ECE/TRANS/WP.29/GRE/57
6 July 2007

Working Party on Lighting and Light-Signalling

**REPORT OF THE WORKING PARTY ON LIGHTING AND LIGHT-SIGNALLING
ON ITS FIFTY-SEVENTH SESSION
(Geneva, 26 – 30 March 2007)**

Figure 1 - Main drawings"

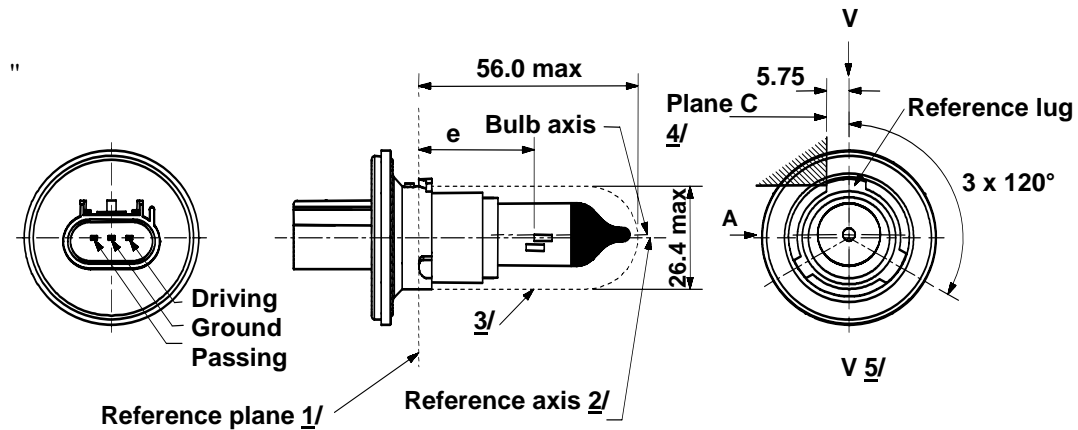
Page 3, sheet HS6/1, figure 1, correct to read:
